STATE OF NORTH CAROLINA
DEPARTMENT OF TRANSPORTATION

Subject: **Supplemental Information for Application for Individual Section 404 and Section 401 Water Quality Certification** for the widening of NC 67 from SR 1355 (Messick Road) to US 601 in Booneville, Yadkin County. State Project No. 6.771008. Division 11, T.I.P. No. R-3415: \$475.00 Debit Work Order 6.771008, WBS Element 34541.1.1.

PROJECT: R-3415
IMPROVEMENT OF NC 67 FROM SR 1355
(MESSICK) ROAD TO JUST WEST OF
BOONVILLE

SITE 3

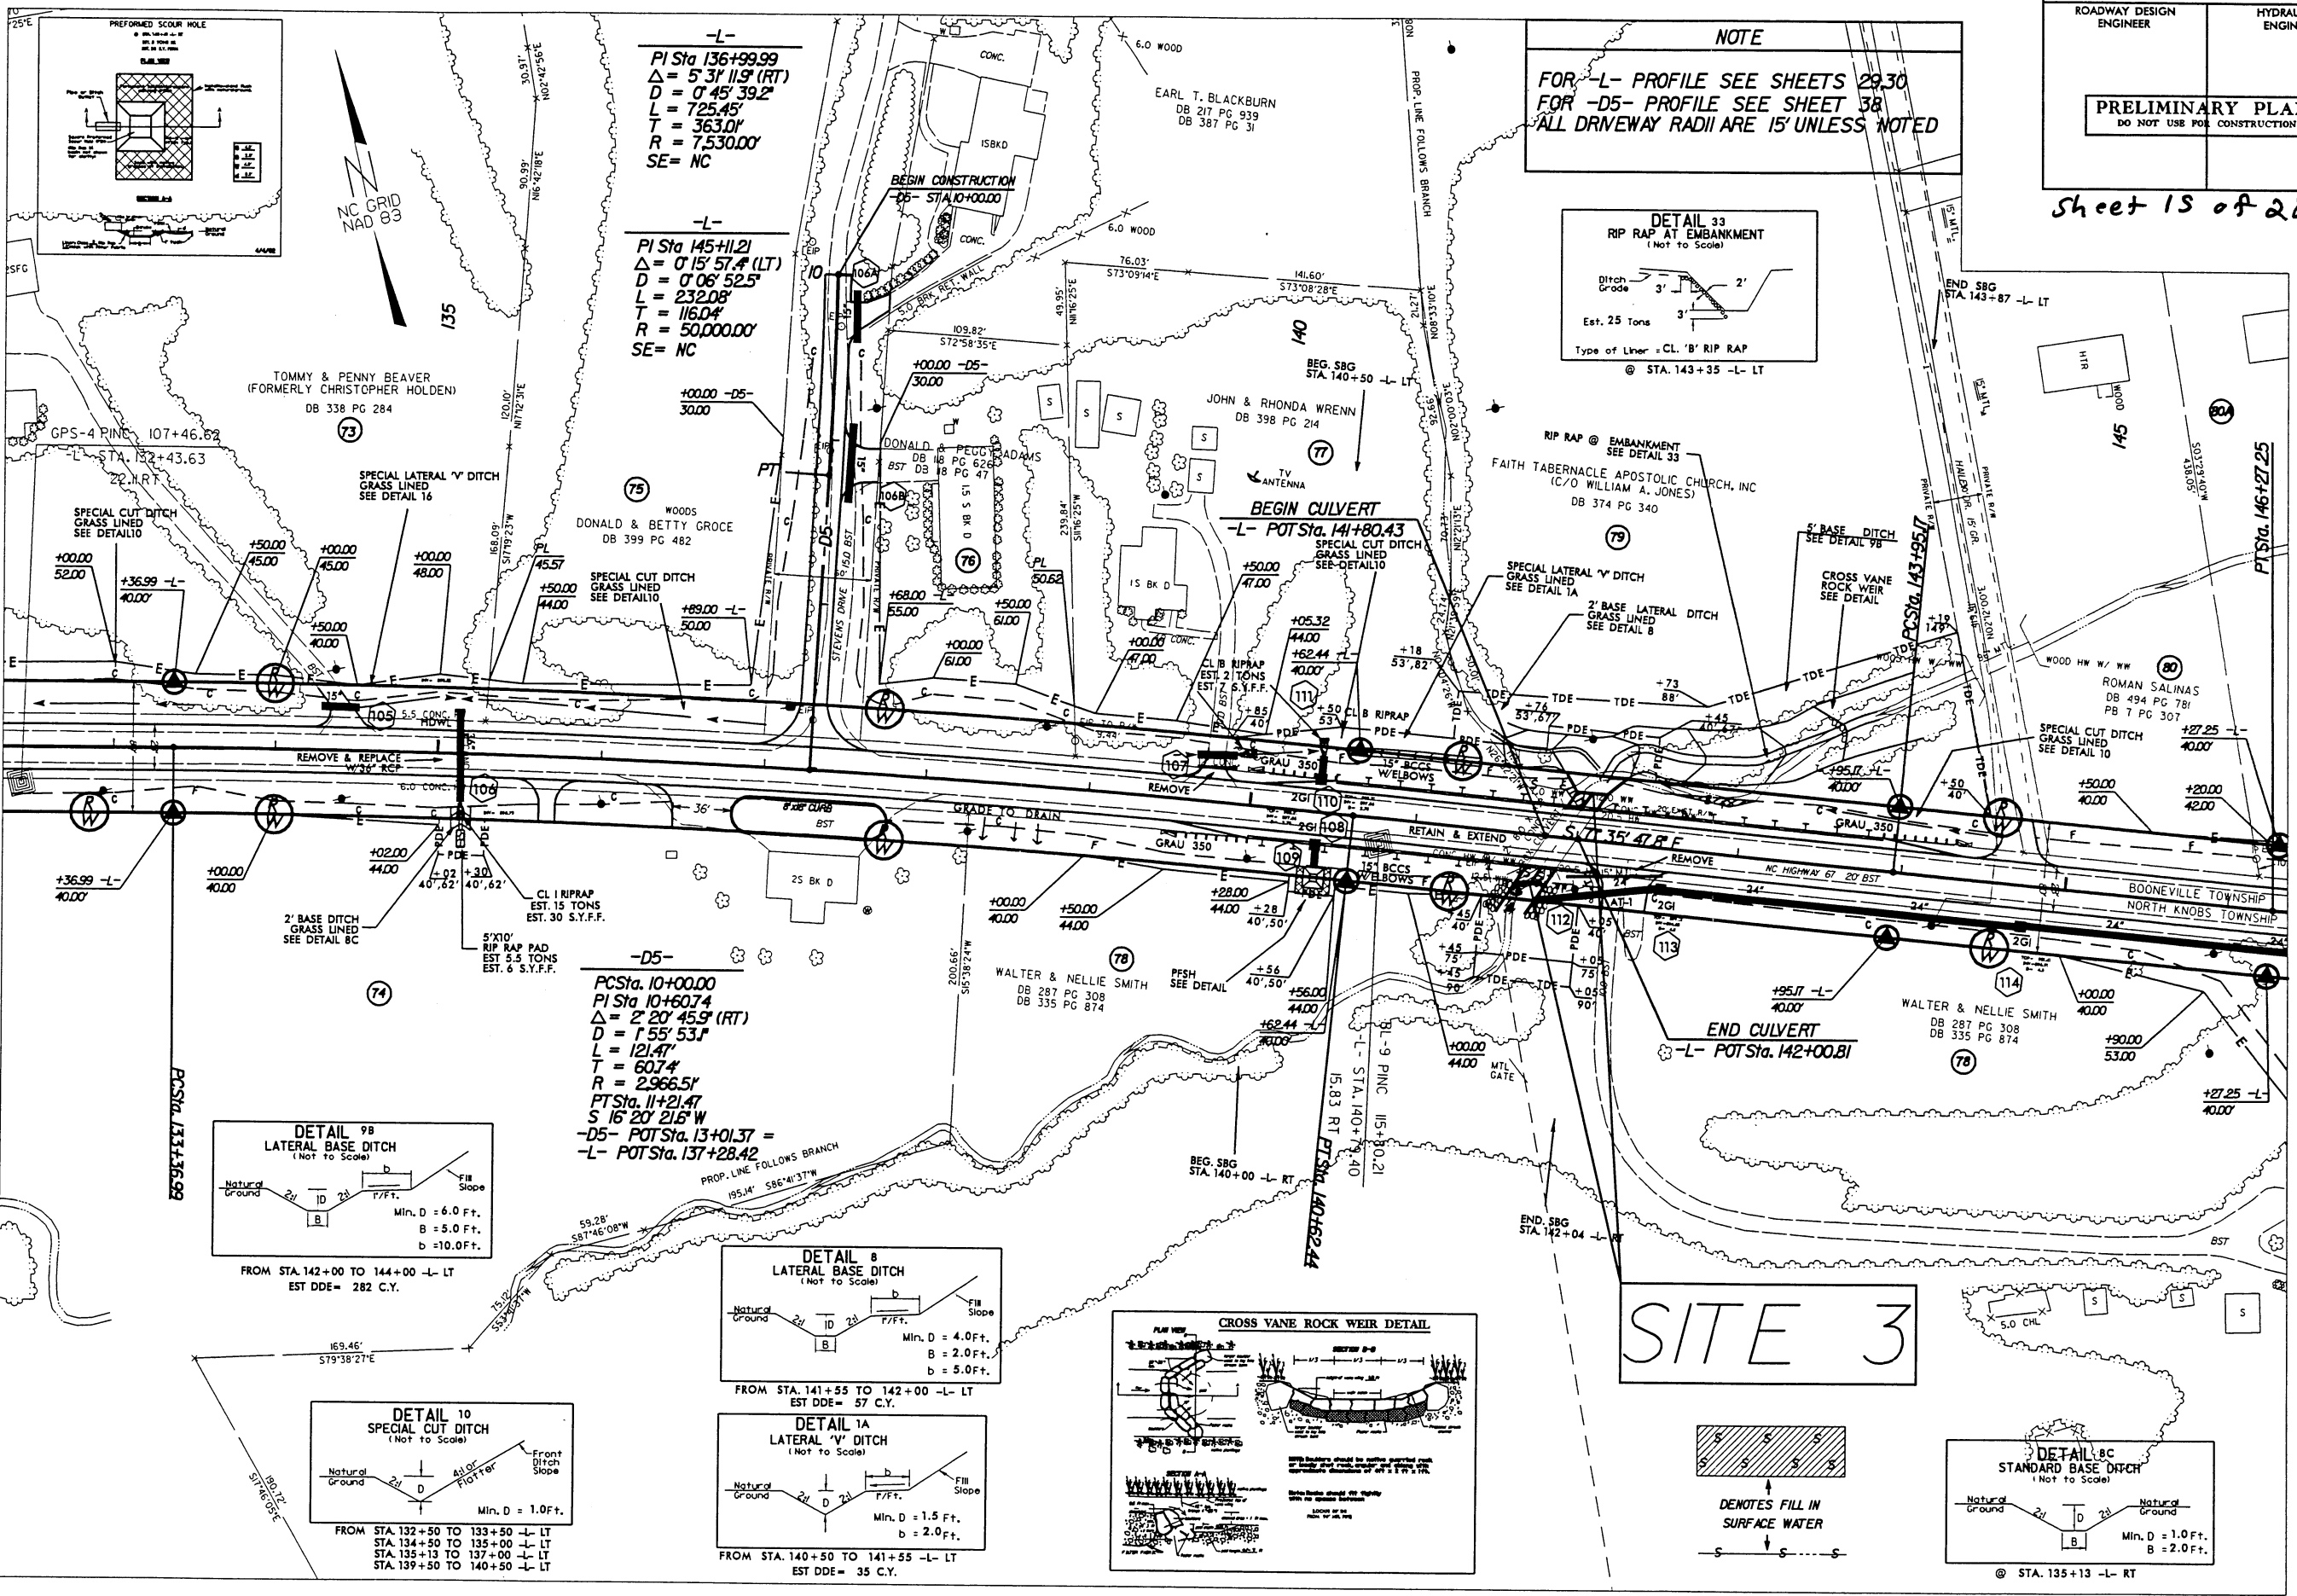
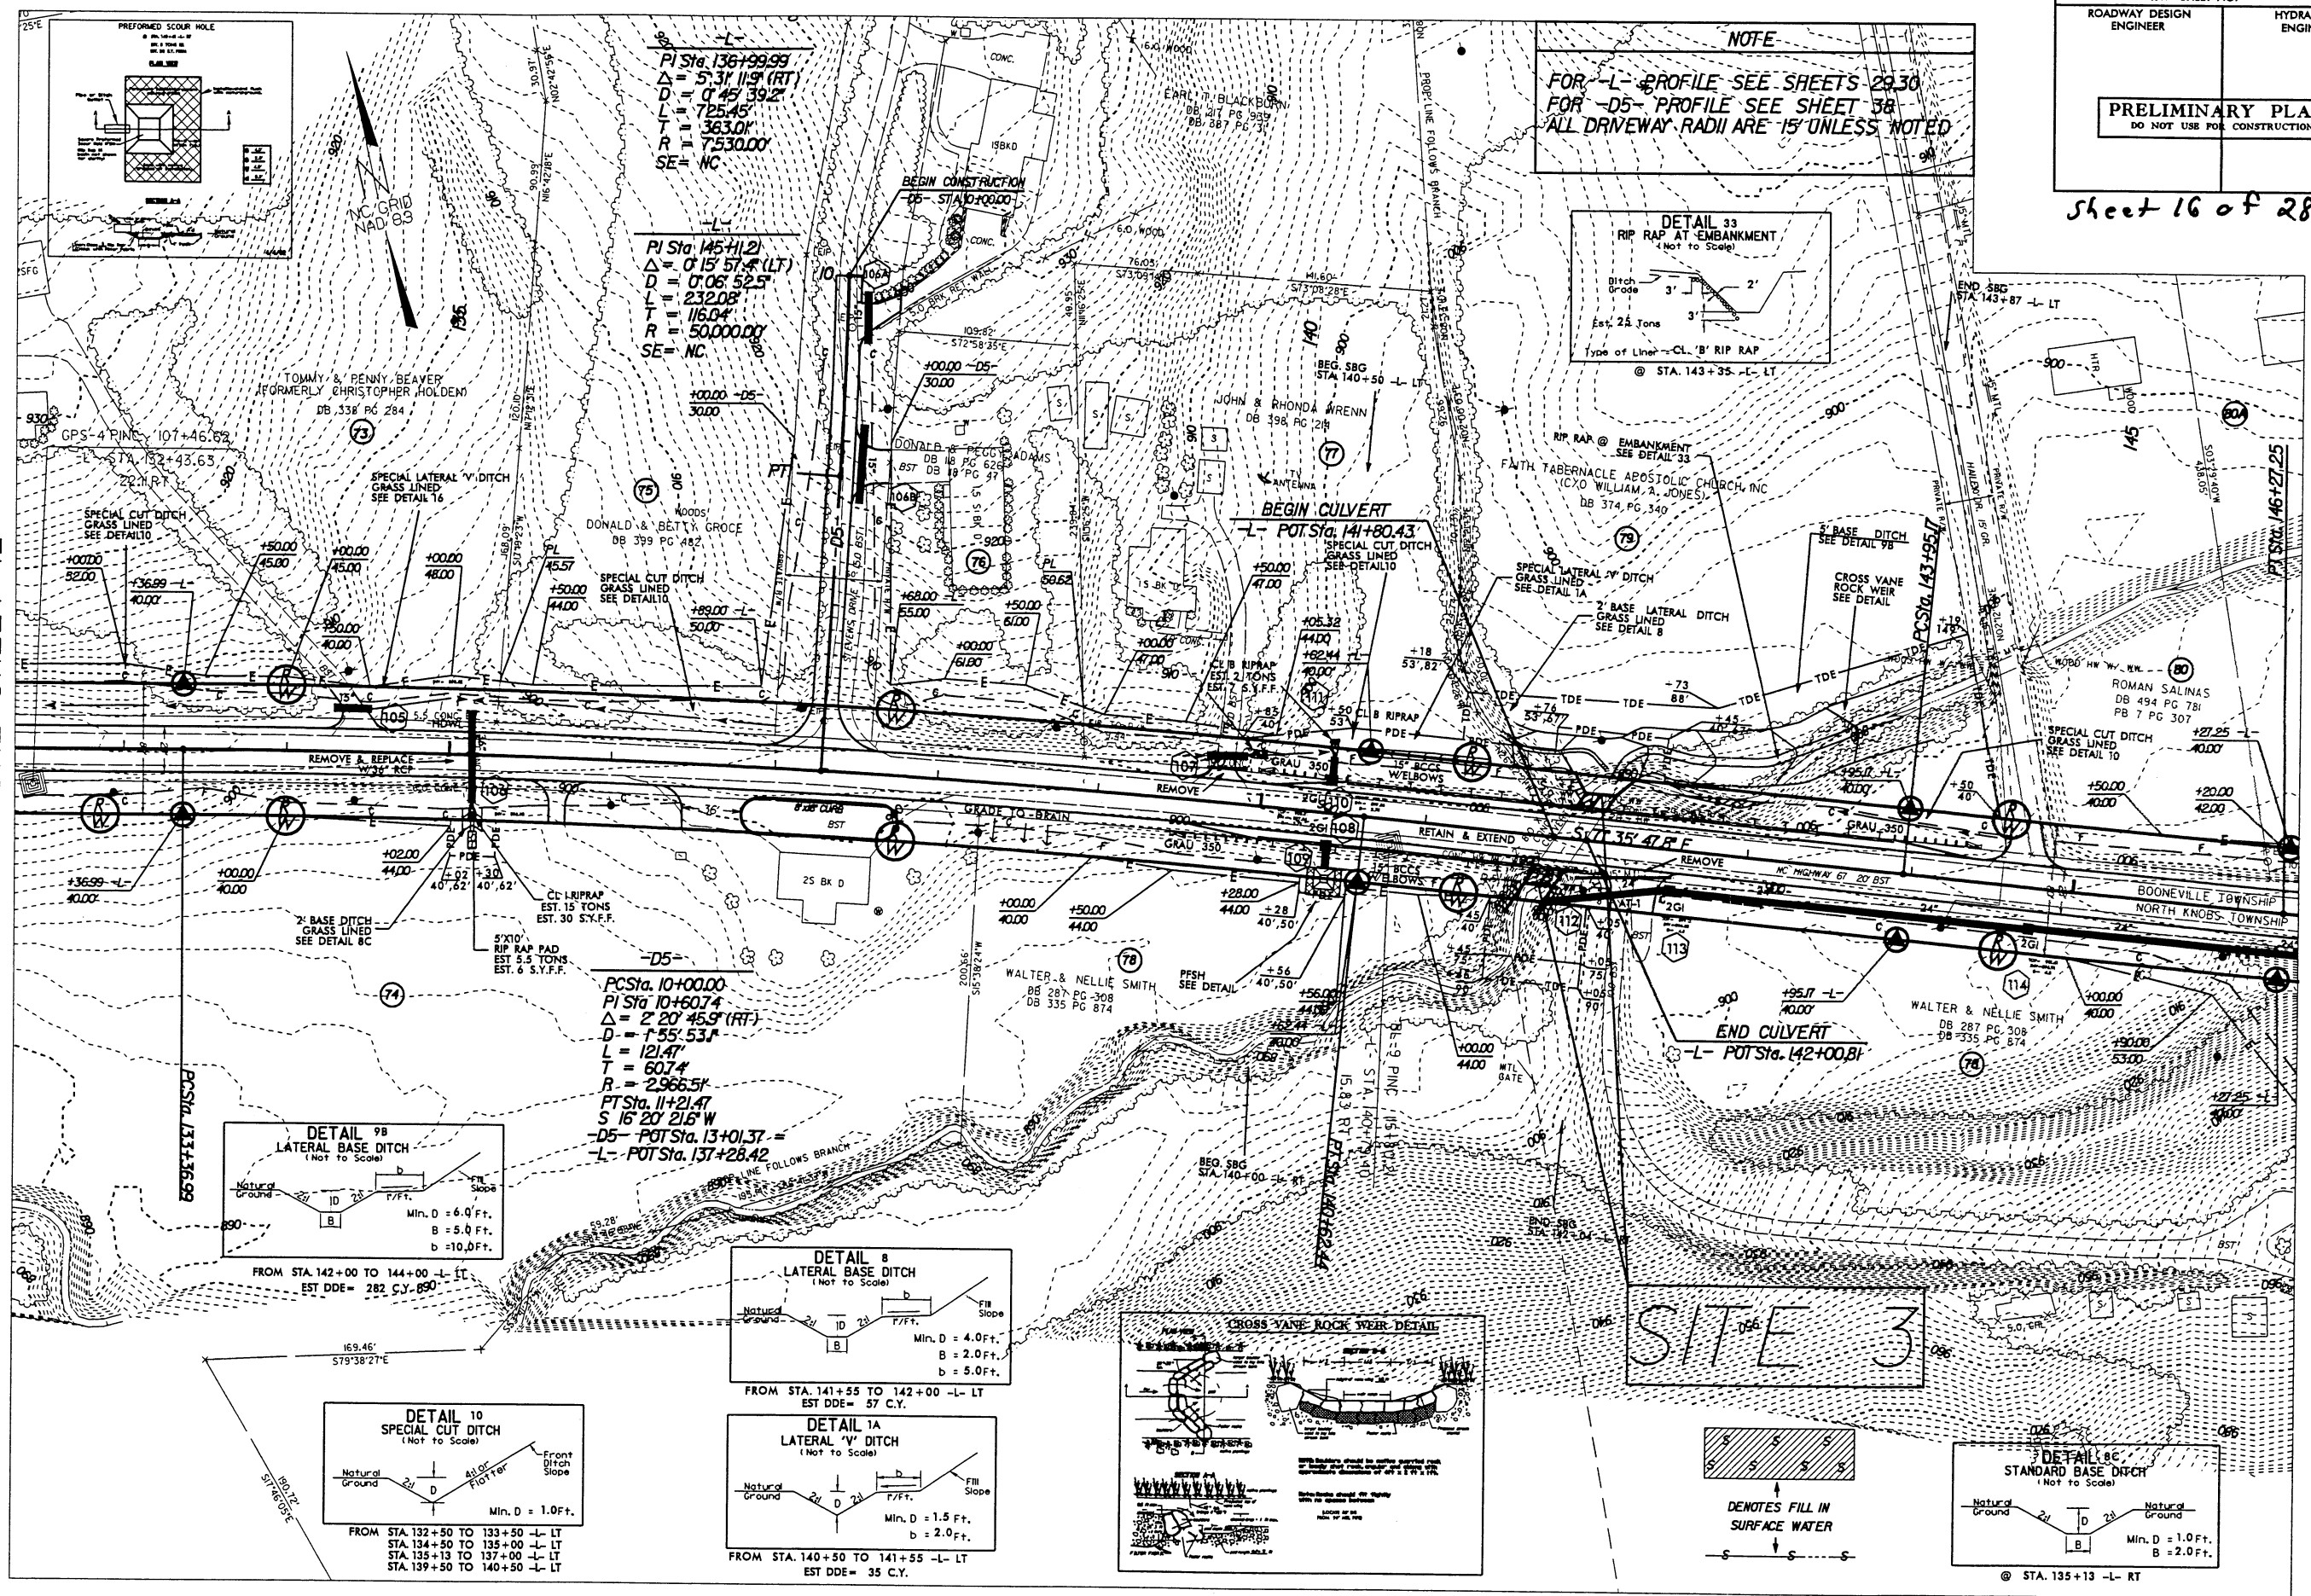
The purpose of this letter is to provide additional information concerning additional impacts to the Site 3 culvert extension. It was determined that impacts associated for the box culvert extension were not calculated correctly. Impacts to the stream will be to the end of the wing walls on the outlet side only because a concrete bottom is needed to construct the wing walls. The additional impact to Williams Creek at Site 3 is 14 ft. The permit drawings were also revised to show this impact and the stream impact symbol was added to the permit drawings. This supplemental information package consists of the cover letter, revised permit drawings and impact summary sheet and EEP acceptance letter.
